# MIT NUCLEAR REACTOR LABORATORY

Subject: License Amendment Request for Position Title Change in Technical Specifications for Level 1 Staff, Docket No. 50-20, License R-37

Safety Review # 2019-29 – Position Title Change for Level 1 Staff  
in Association with NRL Management Restructuring

Figure 7.1-1: Management Organization for Reactor Operations

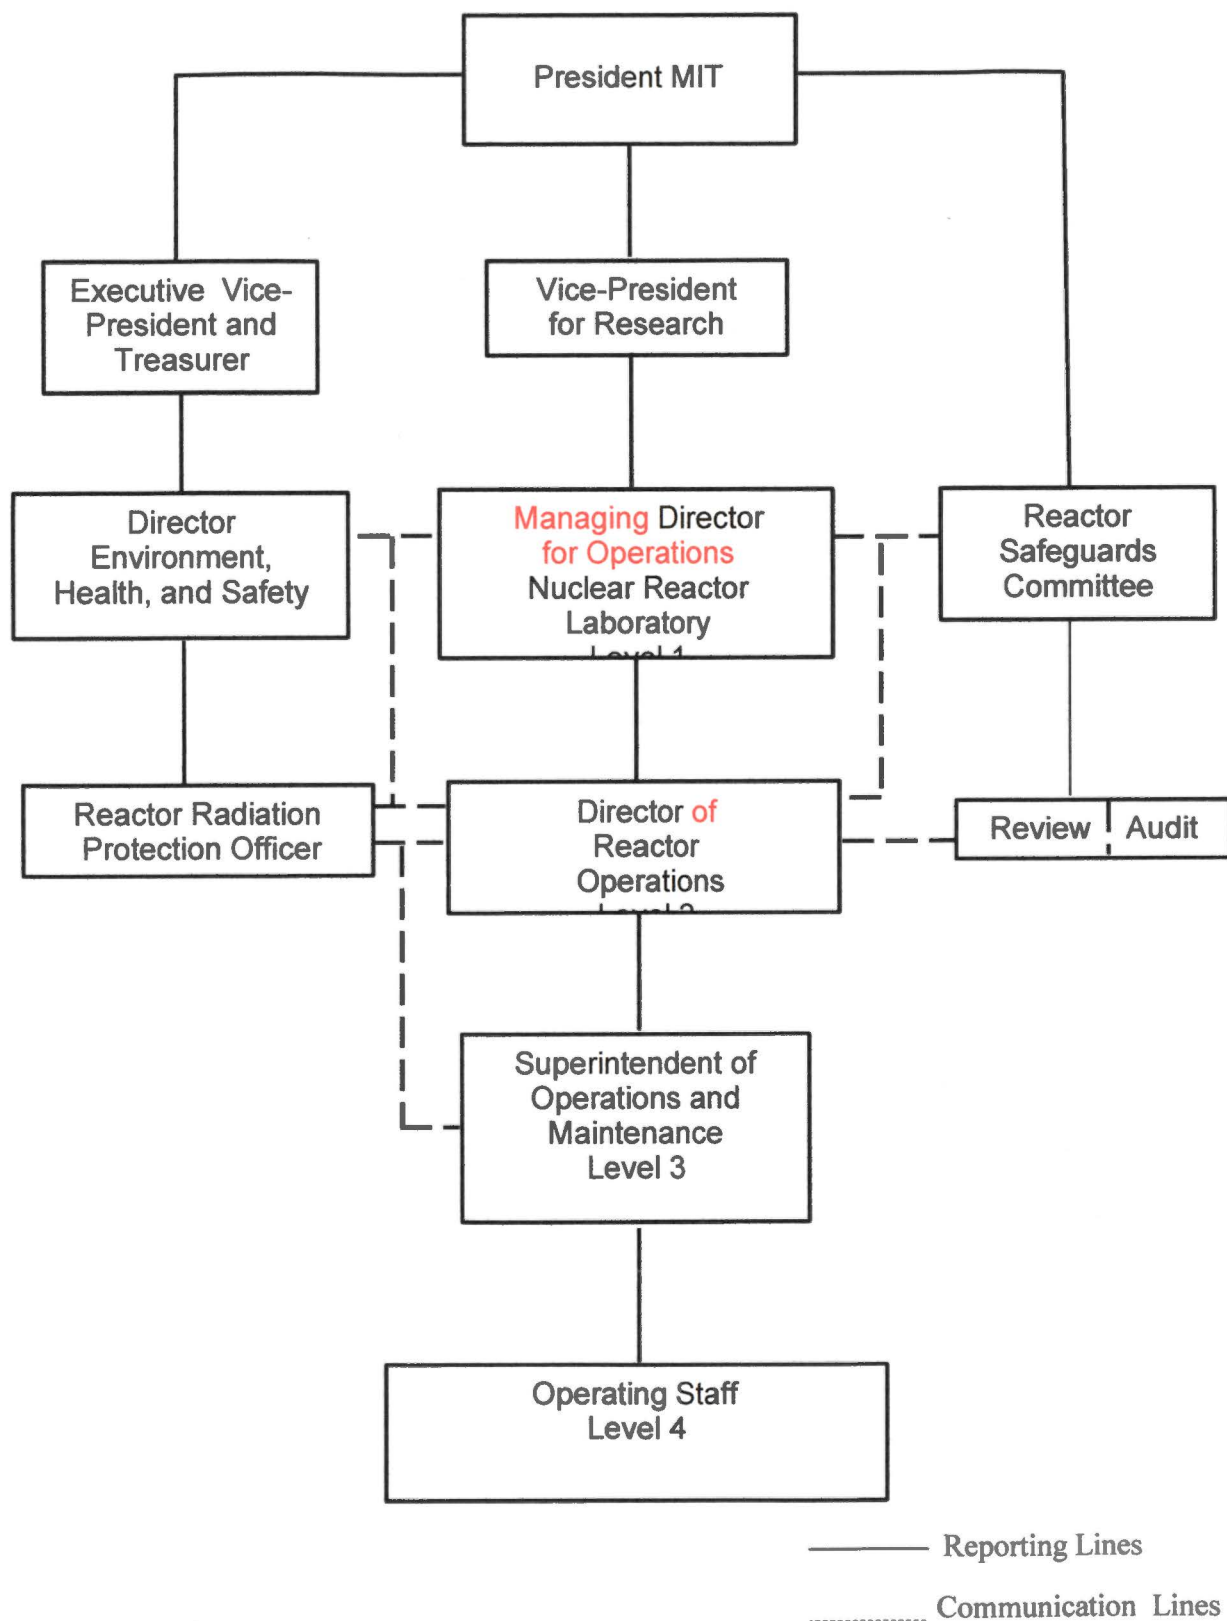
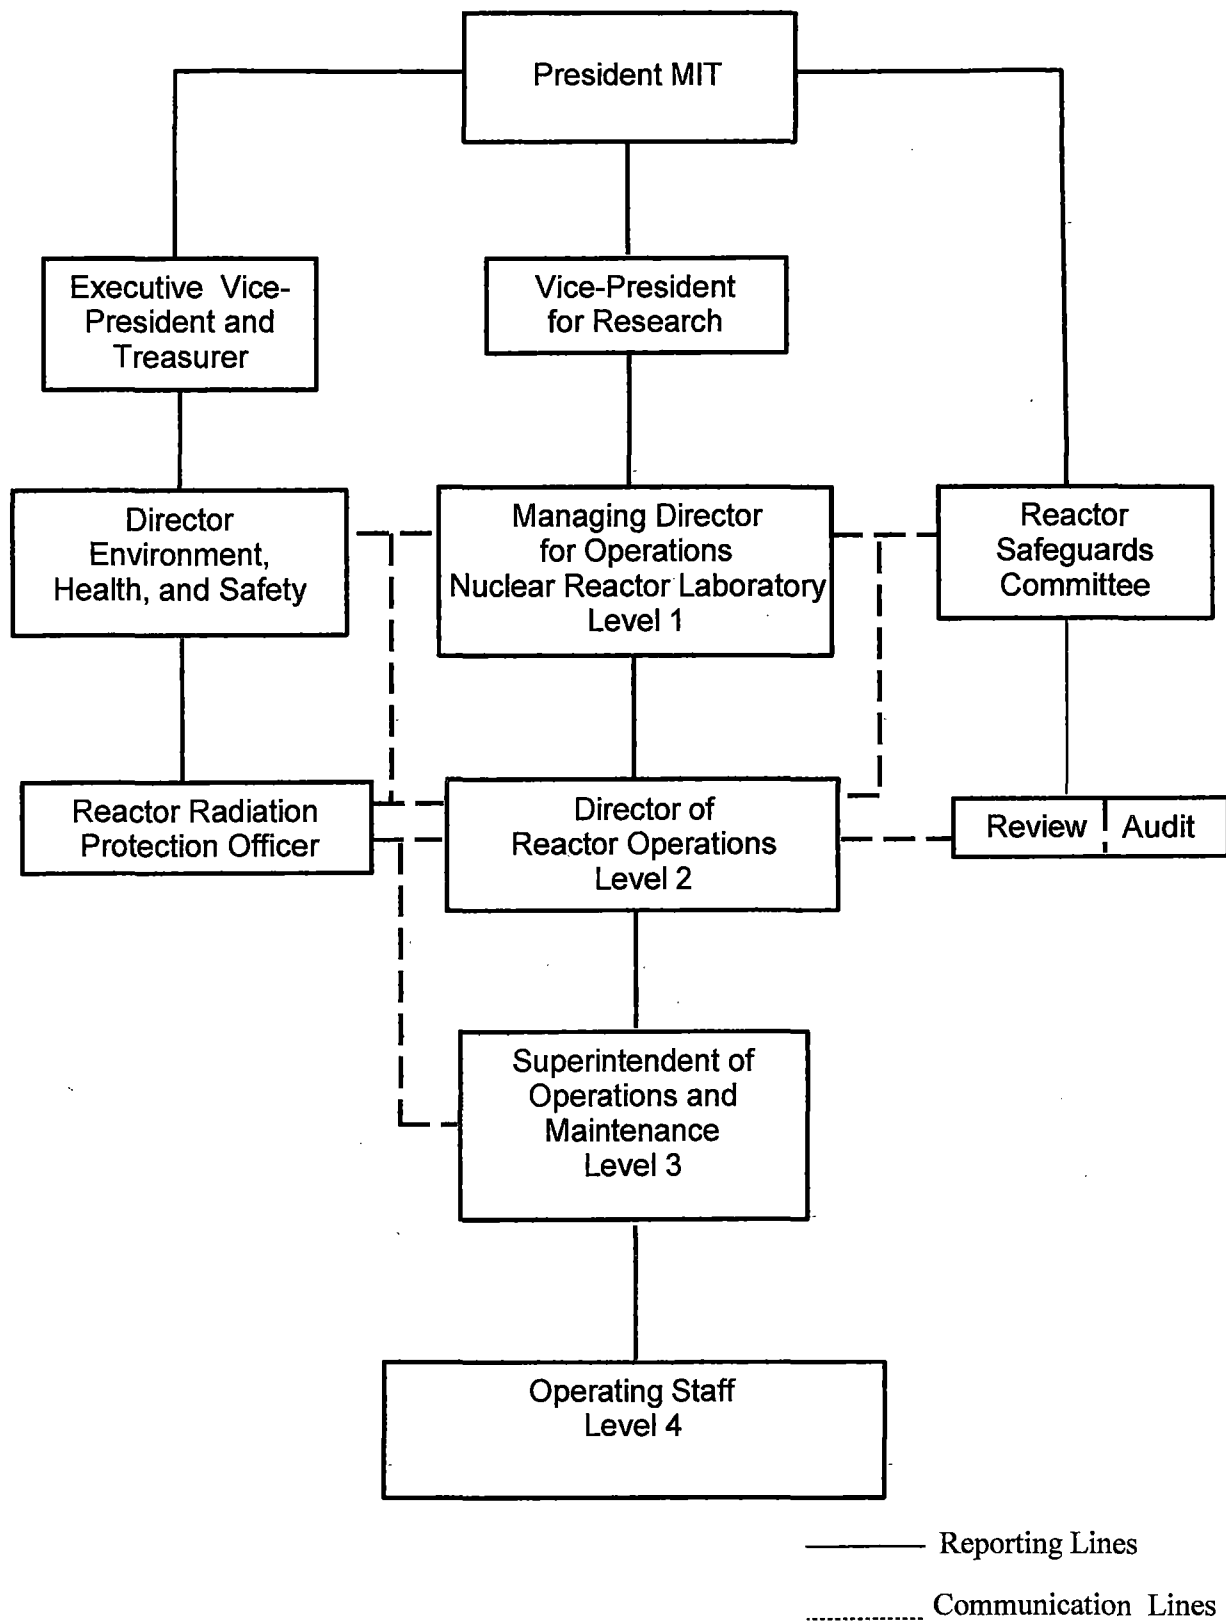
Furthermore, the title of Figure 7.11 is expanded from "Management Organization" to "Management Organization for Reactor Operations", in order to better match the content of the chart.

The Technical Specifications Figure 7.1-1 Management Organization chart is modified accordingly, so that the Level 1 manager has the new title of "Managing Director for Operations", while the title of the Figure is expanded from "Management Organization" to "Management Organization for Reactor Operations" to better match the content of the chart. The other two leadership officials are therefore not part of this organizational chart, as the chart now addresses only the Reactor Operations aspects of the Nuclear Reactor Laboratory.

A further change is made in the Figure 7.1-1 organizational chart to correct a line-break in the block for the Level 2 manager, the Director of Reactor Operations (DRO). The modified layout better matches the text version of the title as used in TS 7.1.2.1 (responsibility), TS 7.1.4.1 (DRO requirements), and elsewhere throughout the document.
